Re: Wilmington Harbor 403 Draft Letter Report and Environmental Impact Statement,  
Wilmington Harbor Navigation Project, North Carolina

**SUPPLEMENTAL COMMENTS SUBMITTED ON BEHALF OF THE VILLAGE OF BALD HEAD ISLAND  
REGARDING ECONOMIC ANALYSES:**

**Figure 2 Restructuring of Asia/USEC EC2 Service**

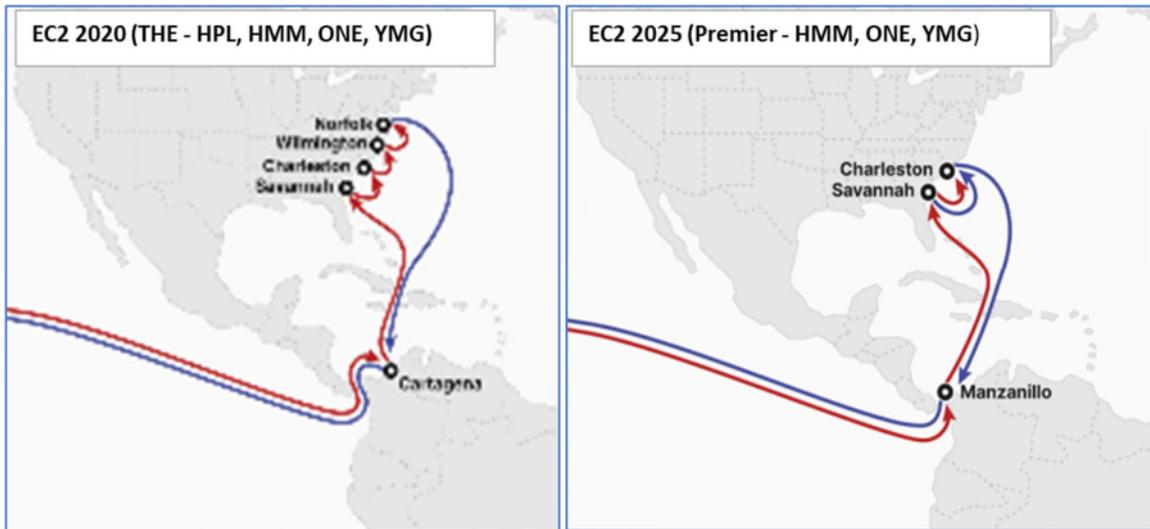
Following the restructuring, the Premier Alliance revised its network of Asian services, including the EC2 service that used to call at Wilmington. The updated EC2’s port rotation dropped Wilmington and Norfolk, following a decline in the Asia/USEC trade route. **Figure 2** shows the route maps of the EC2 Asia/USEC service before and after restructuring. The service pattern of EC2 is through-Panama and it is operated by a mixture of PPX2 & 3 (see Table 9 in Appendix B).

**Figure 7 Wilmington's Calls Distribution by PPX Categories**

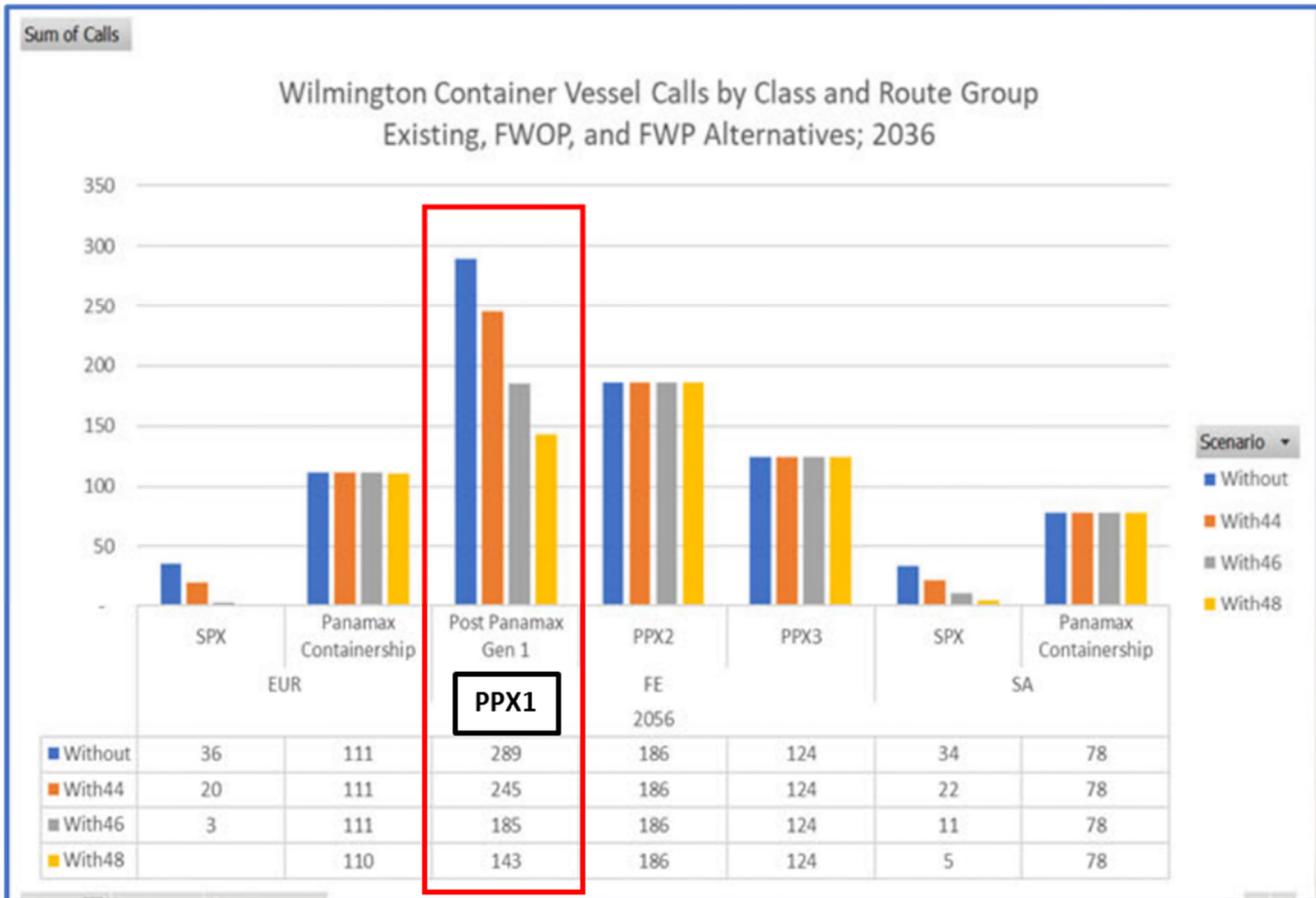
As seen in Table 4 and illustrated in Figure 7, the number of calls of PPX2 & 3 (in red) remained **unchanged**, despite the dramatic, 320% growth in cargo volume (Table 2) and the increase in channel depth in the With cases. **The only change is in the number of calls of PPX1.** It seems, that 2025 EC assumes that PPX1, which already in 2021 became extinct on Asia/USEC services, are expected to re-emerge 15 years later, in 2036 and remain fully deployed even in 2056. To re-emphasize, in 2021, the base year for the 2025 EC report, Wilmington had 2 Asian services: ZCP provided by PPX2 and EC2 PPX3 – **no PPX1**. Moreover, **Figure 8** below, taken from 2020 NCP, p. 29, shows that PPX1 had already become extinct in 2019 (red square).

**Figure 10 The "Jump" in Wilmington's Forecast**

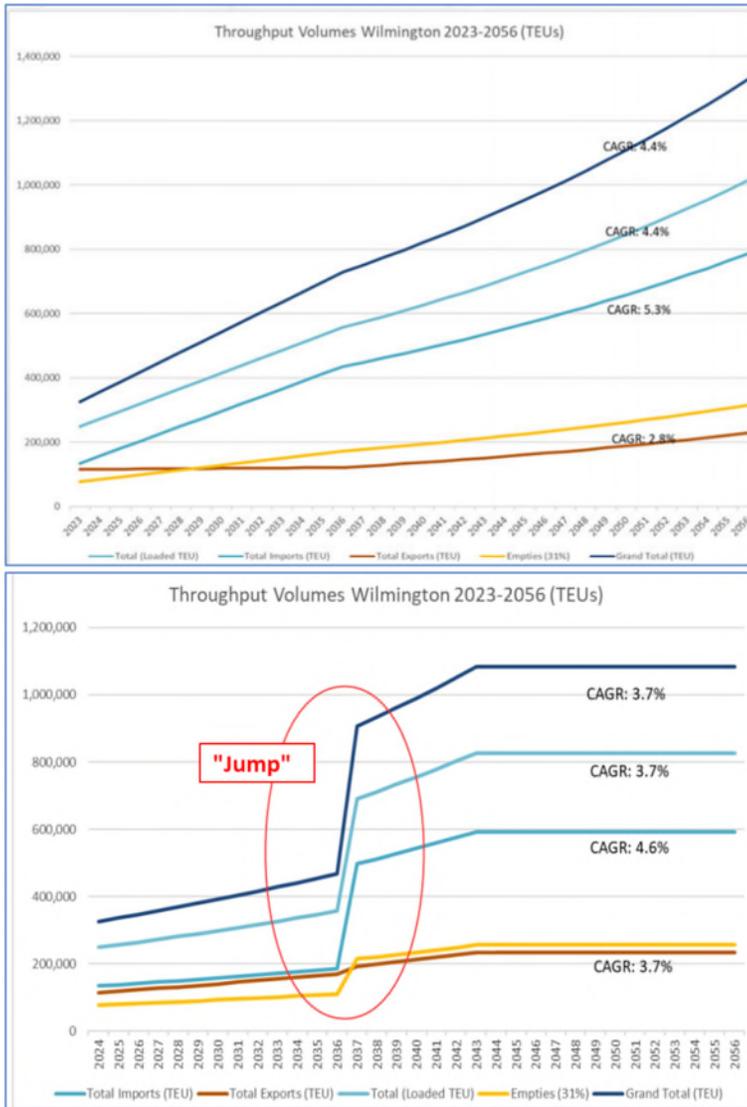
The upper part shows gradual and stable growth rates, with no bumps and no jumps, similar to the one presented below for the Port of Oakland in the following Figure 11, and similar to the many USACE channel studies I have reviewed in recent years. The lower part of Figure 8 shows the "jump" (red circle added by me). Interestingly, both charts were prepared and presented in 2024, perhaps by two separate researchers.

As I noted in Section II, 2025 EC does not offer an explanation for the “jump” or the emergence of these 306,000 TEUs, except for indicating, somewhat causally, that it is presumably the result of “\$10 billion investments planned for the next years”. 2025 EC does not provide a list of the planned, new or expanded, local industries, and for each an estimate of tonnage and TEUs projections for each. There is also no reference to studies that discuss and explain this unusual growth in imports. In this appendix, I attempt to provide my own, although rough, estimate of Wilmington’s expected growth in Asian imports, resulting from the above-mentioned investments.

**Figure 11 Cargo Forecast for the Port of Oakland**

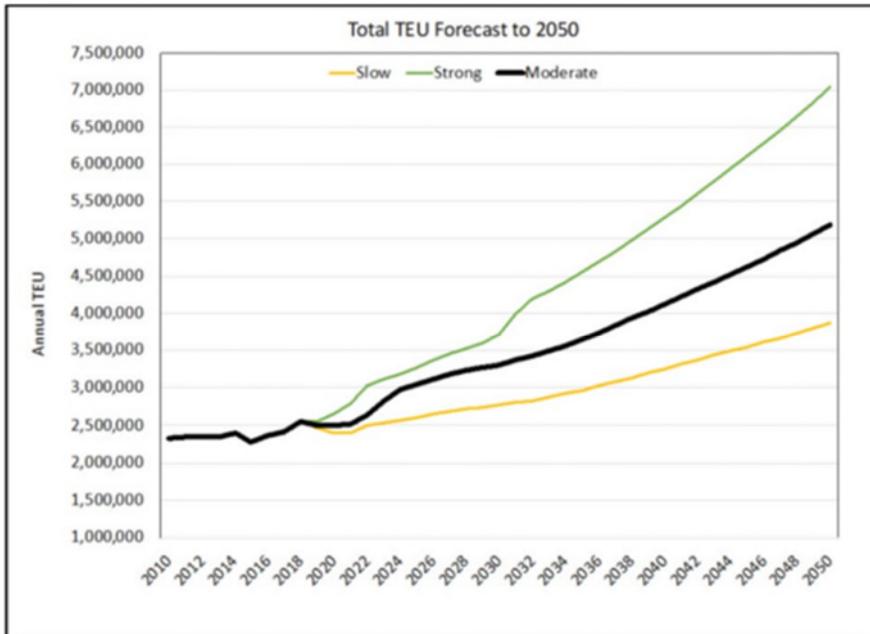
**Figure 11** shows the Port of Oakland's forecast for 40 years, taken for USACE study of Oakland, CA. This figure shows steady growth rates similar also for a USWC port. Why does 2025 EC apply a different forecasting methodology to Wilmington?

In both Table 8 and Figure 11, the forecast includes 3 growth scenarios, low, moderate and high. This also is the case in Figure 10, upper part, that shows Wilmington’s forecasts in 2024 PowerPoint. However, 2025 EC provides **only one scenario**, presumably the moderate growth, with no explanation given. As will be seen in the following sections devoted to a discussion of the specifics of the “jump”, there also are no scenarios there. It seems that this avoidance of scenario-based assessment is in line with the overall analytical approach of 2025 EC, which for unknown reasons excludes sensitivity testing of its assumptions.

**Figure 12 World Fleet by PPX Categories**

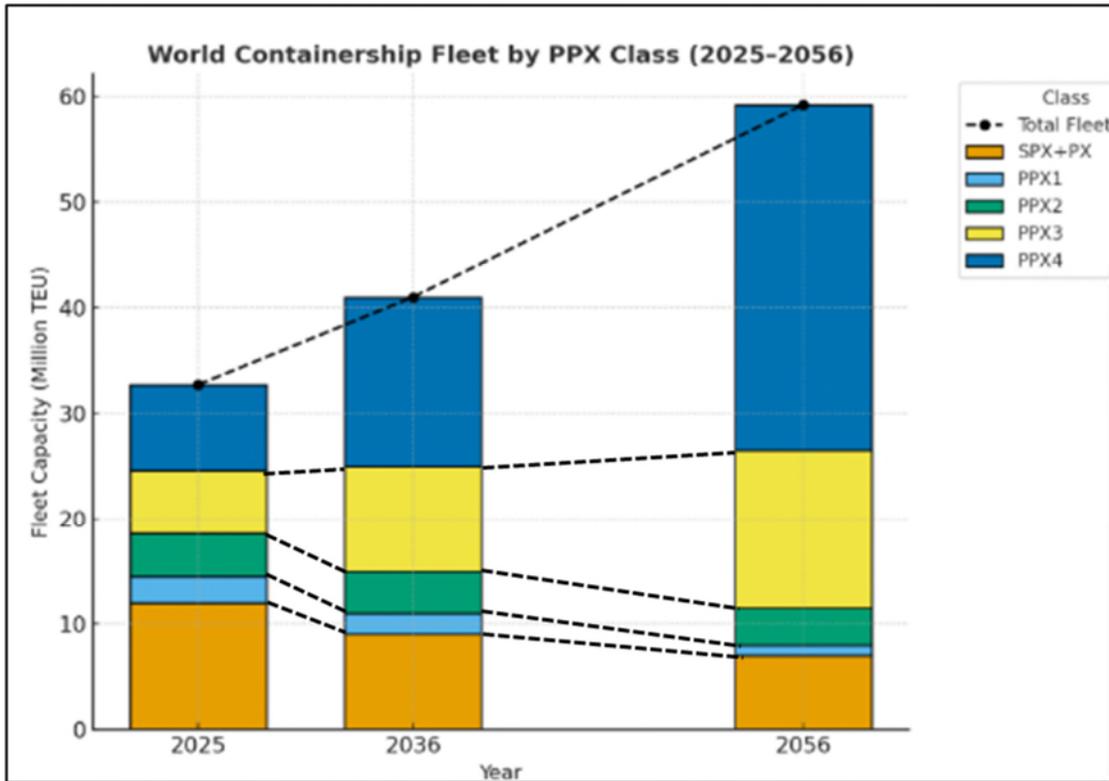
As seen in Figure 12, PPX1, the dominant vessel in 2025 EC, and the main source of savings due to the predicted reduction in the number of calls, is bound to almost disappear. The largest category of the PPX in 2025, PPX3, is expected to further grow, while PPX2 remains unchanged. Another trend is the tremendous growth in PPX4. These 24,000-TEU vessels, already dominating the Asia/Europe trade are likely, eventually (2036?), following the next round of USEC-ports' deepening, to also dominate Asia/USEC services, which by then will mostly be through-Suez.

How can one predict the reappearance of PPX1-based services in 2036, when most of them are already bygone as seen in Figure 12?

Another hurdle for such a service is a severe shortage in PPX1. As seen in Figure 12 above, the availability of smaller PPXs will sharply decline in the future. The reason is simple, there is and will be a limited worldwide use for this historical, small-capacity vessel design.
